DESIGN AND ACCESS STATEMENT
NON-MATERIAL AMENDMENT
PHASE I CIRCULATION CORE
SEPTEMBER 2015

FORBURY PLACE

Job	FORBURY PLACE PHASE I & II		Job Number	20918	
Document Title	D.A.S FOR NON-MATERIAL AMENDMENT TO PHASE 1 CIRCULATION CORE		Document Number	20918-01-RP-00-133	
Prepared for	Reading Borough Council		Distribution		
Revision	Date 22/09/15		Prepared by	Checked by	Approved by
A B C		Name	RS	CG	LS
		Signature

non-material amendment to Phase I Core A - SITE PLAN
[Extract of drawing 20918-01-AR-07-100A]
Not to scale

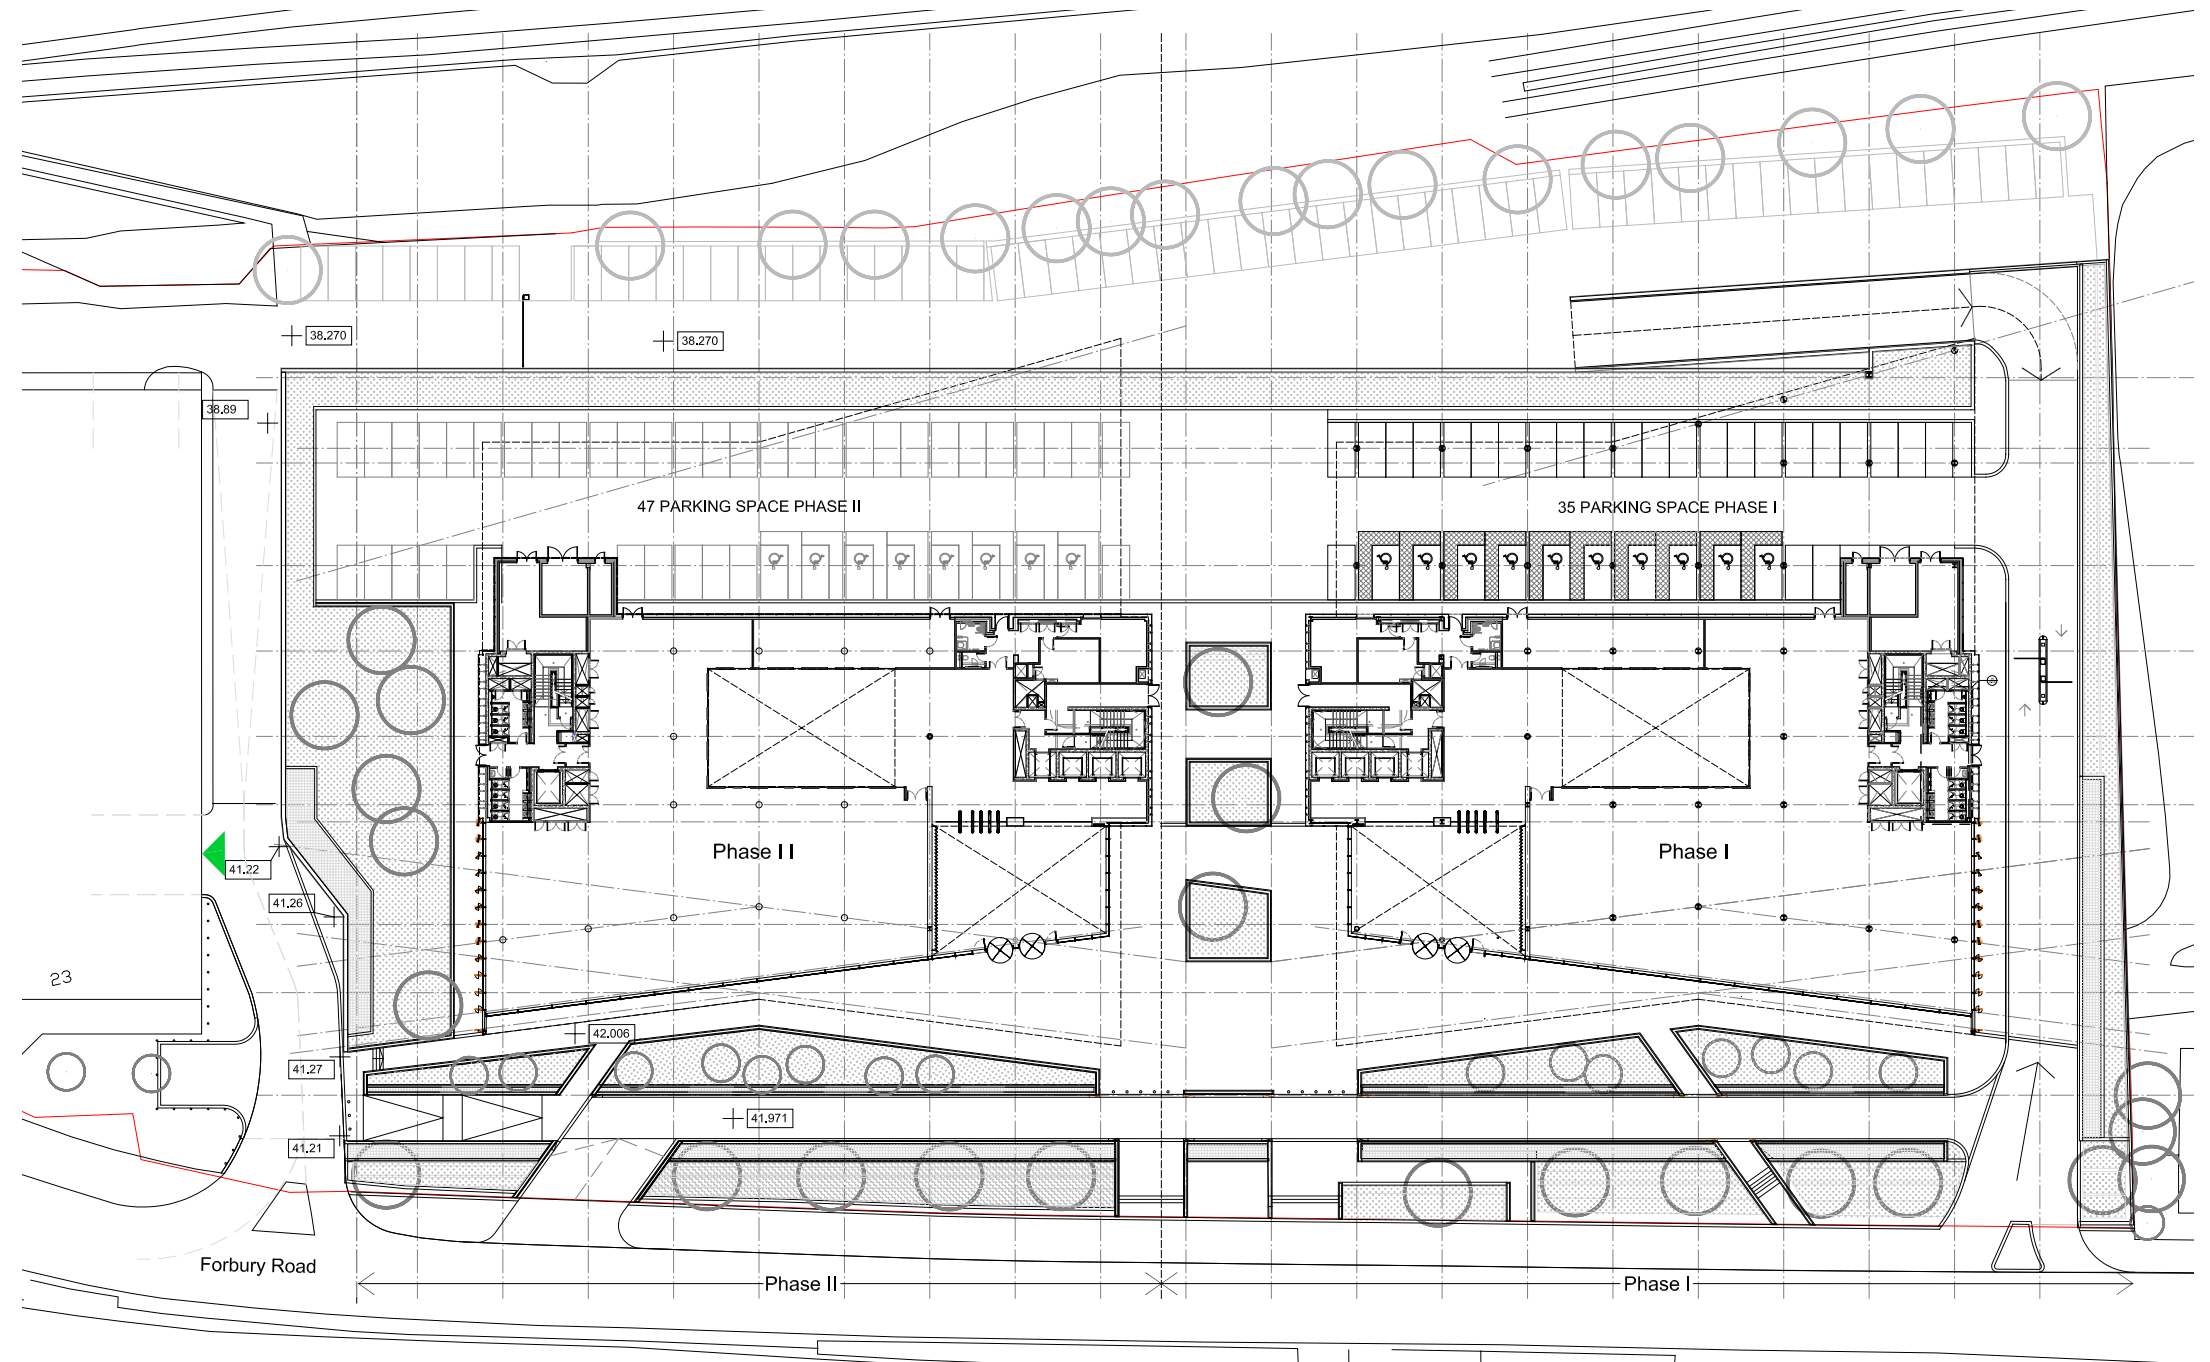
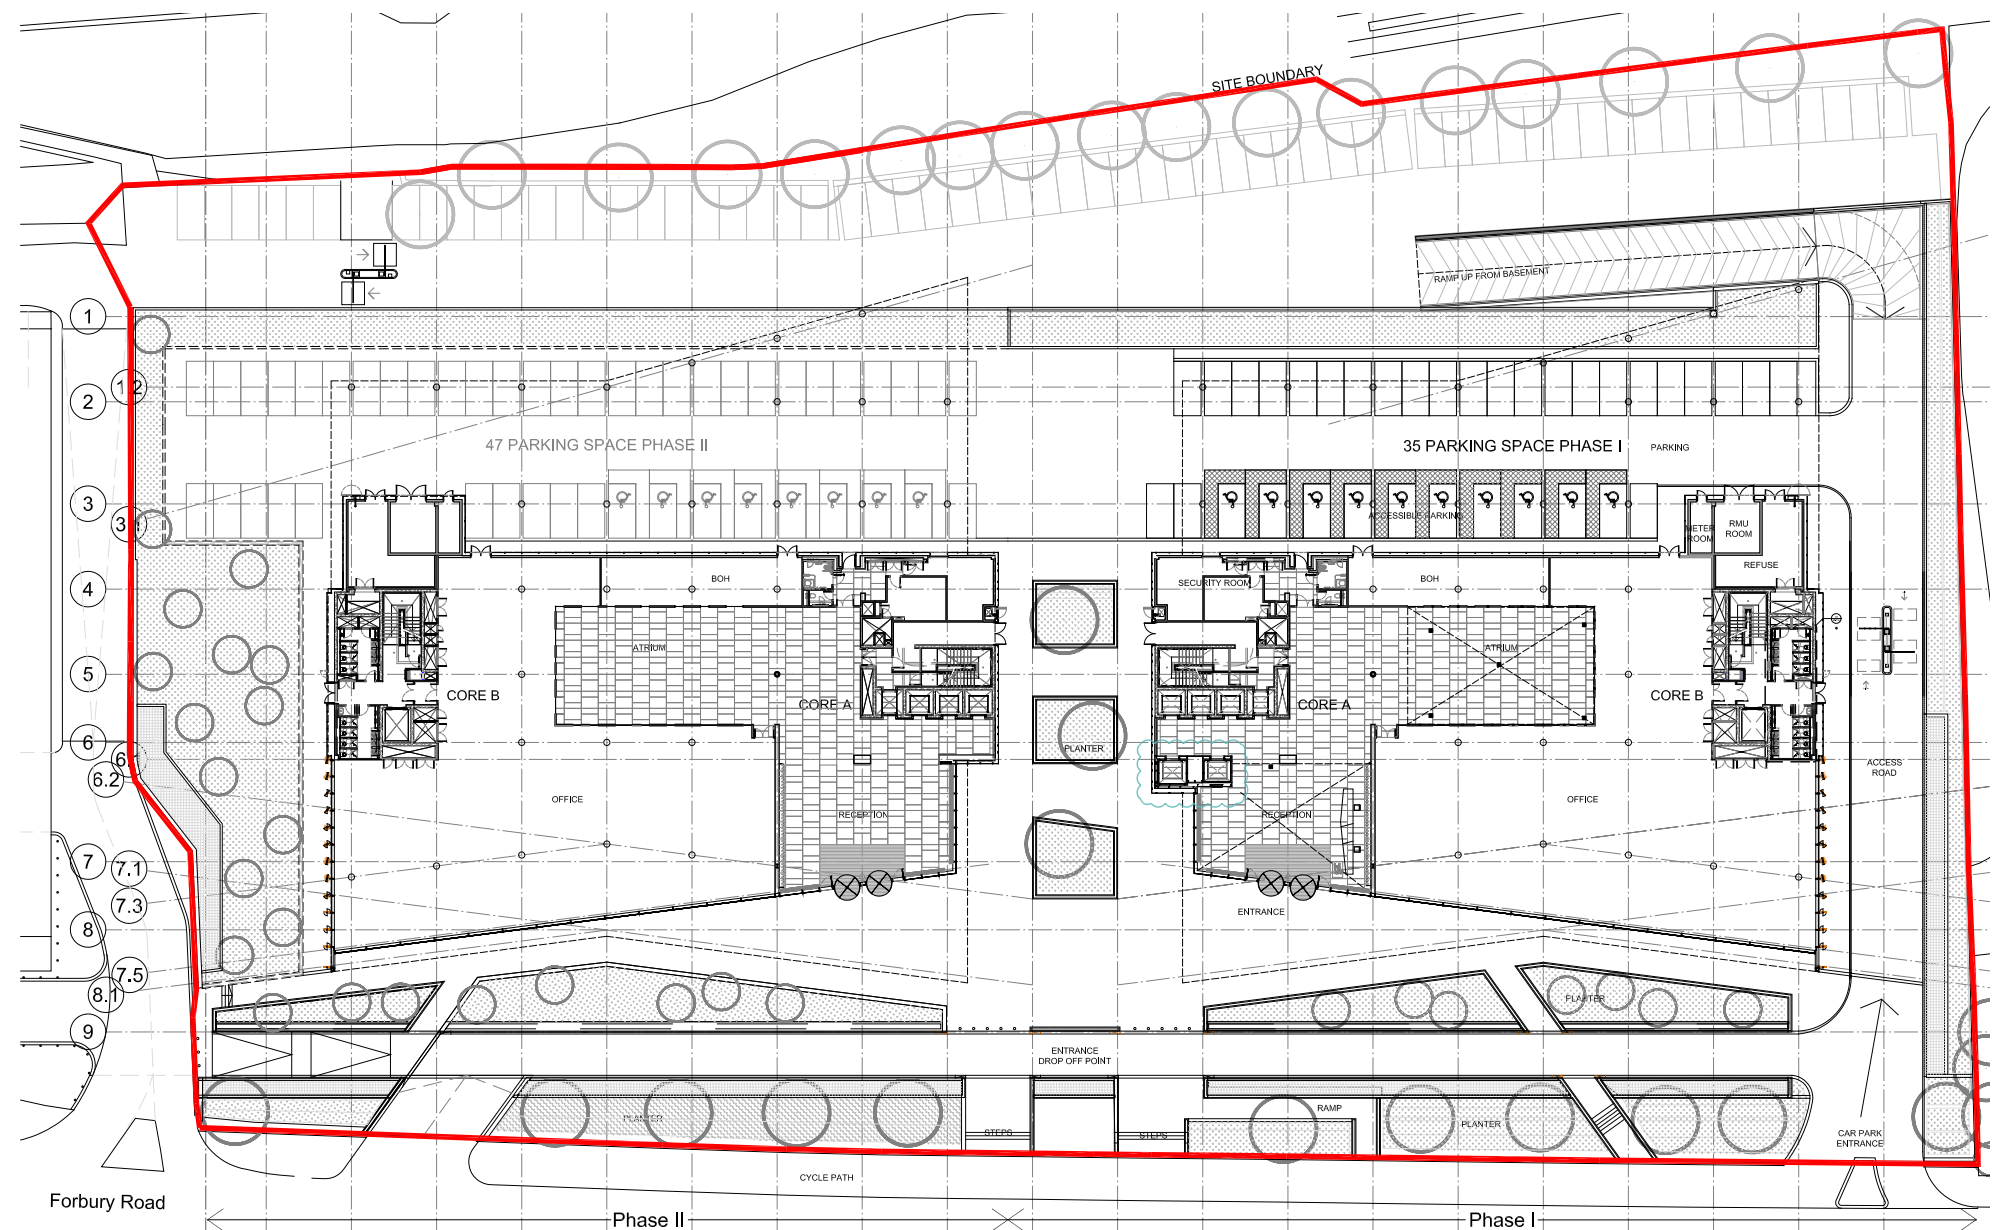
Two new lifts have been added to Phase I Core A (West) as highlighted. One lift is located internally within the reception area, and one external of the existing building external envelope. Both lifts have been grouped together with the existing lifts to the building.

The result of this change at ground floor is a minor increase in GEA.

This design approach for additional lifts would also be considered to phase 2, to so that the buildings continue to mirror each other.

non-material amendment to Phase I Core A - BASEMENT PLAN
[Extract of drawing 20918-01-AR-07-99C]
Not to scale

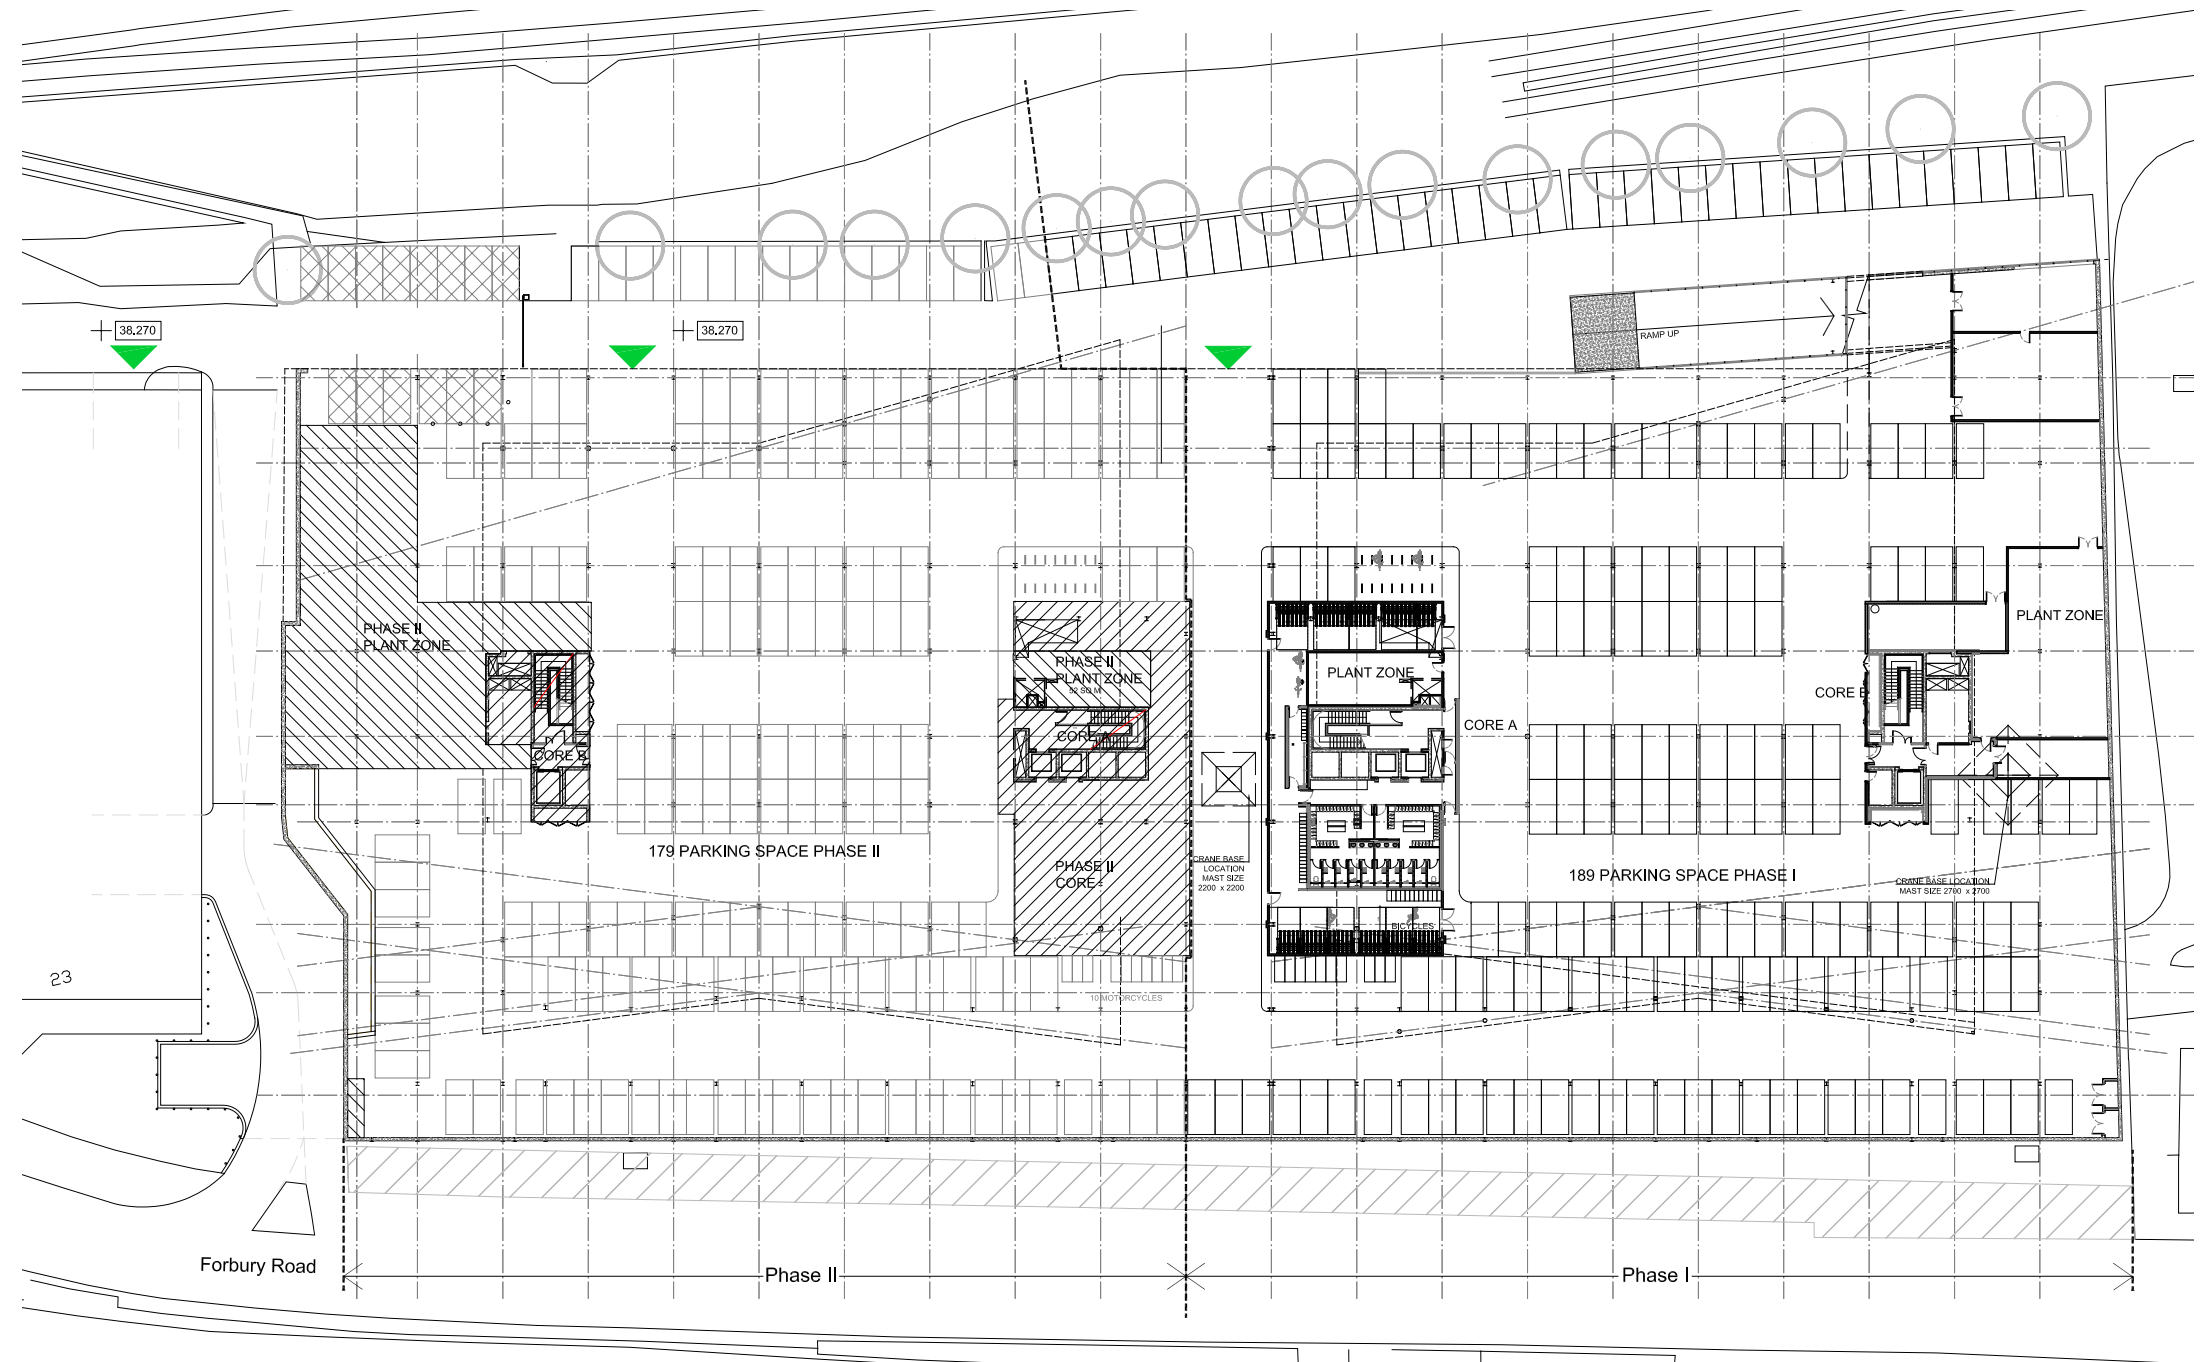
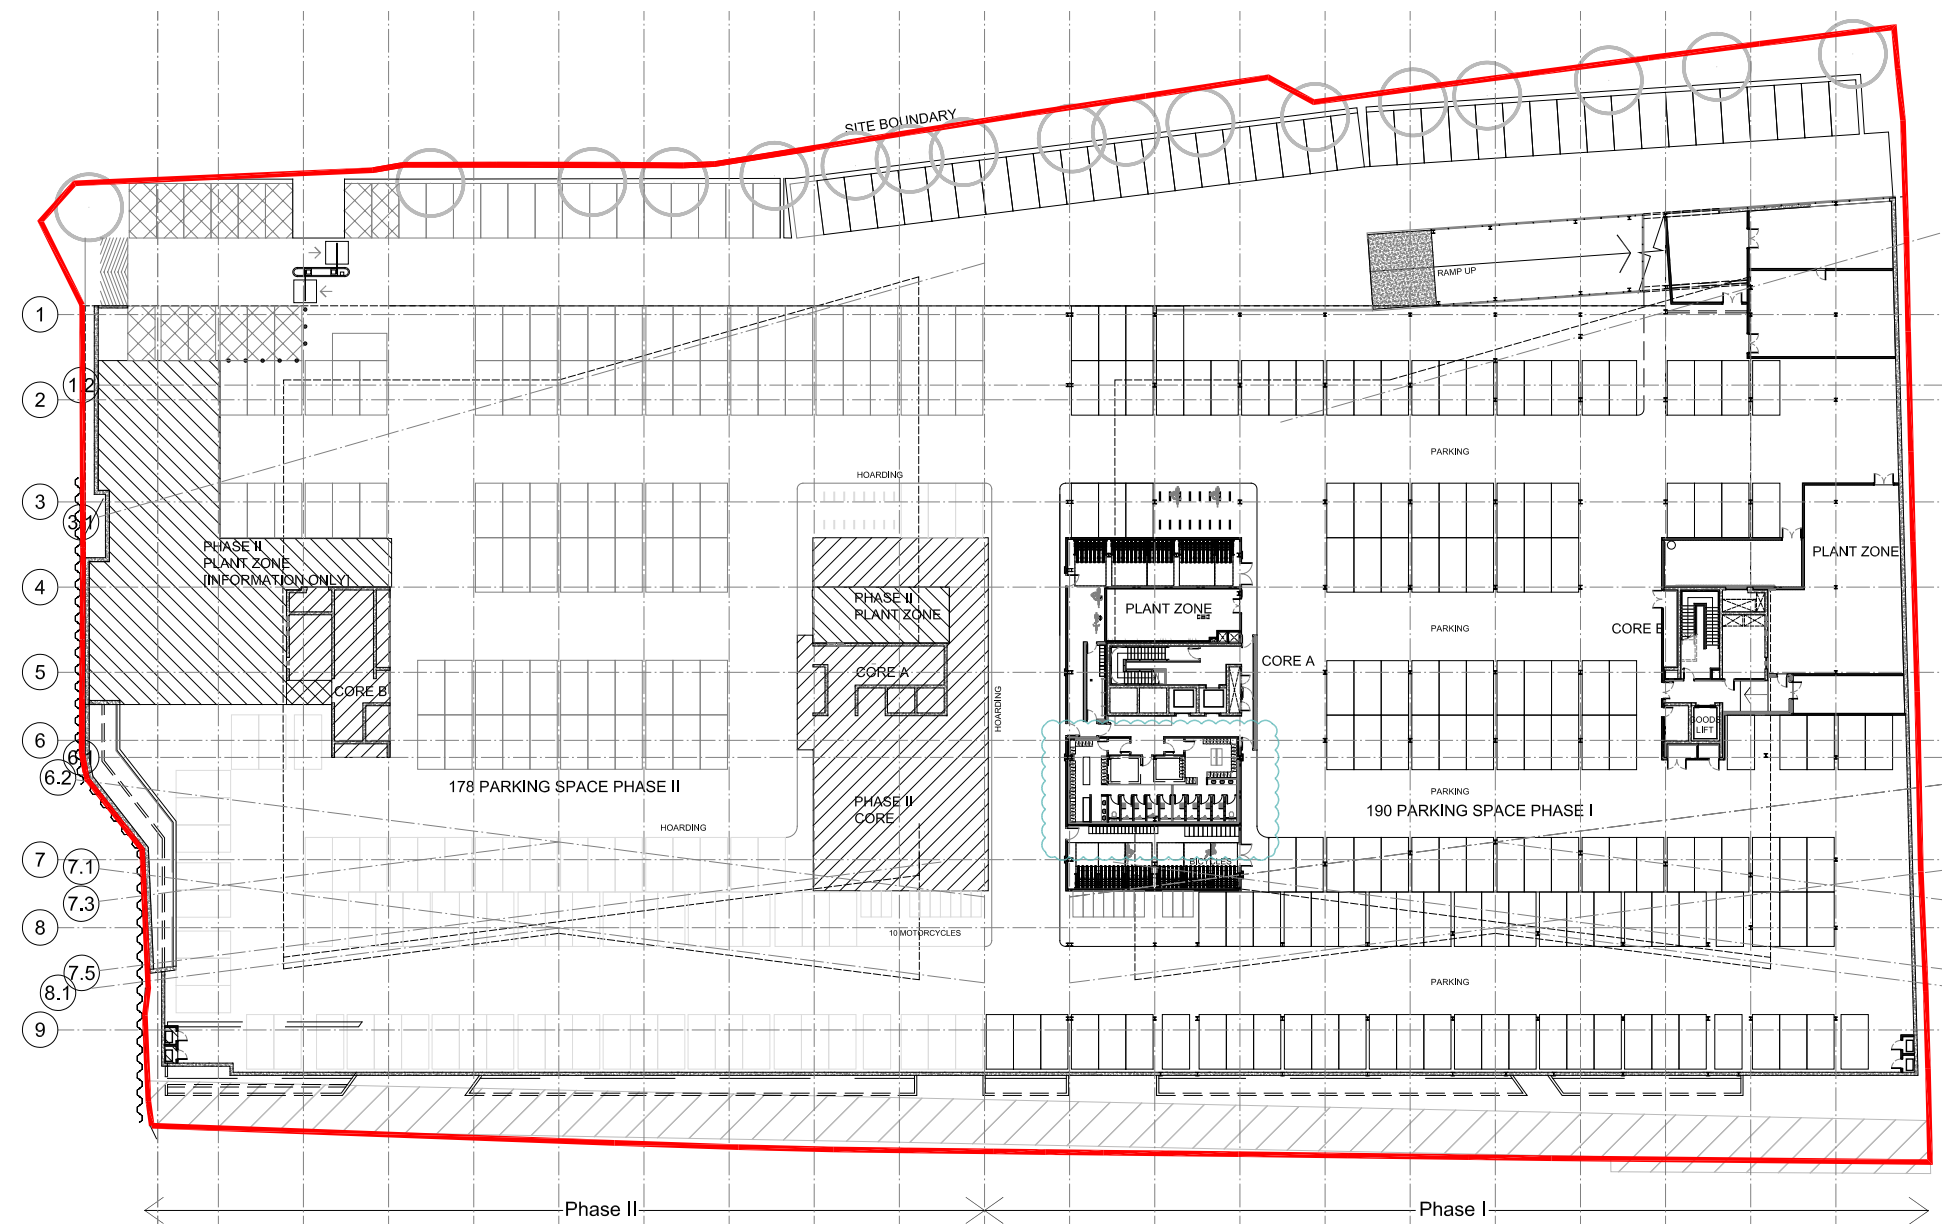
Location of the two new lifts to Phase I Core A (West) at basement level.

The GEA to the core remains as approved and there are no changes to the parking layout or the number of cycle spaces and their associated facilities.
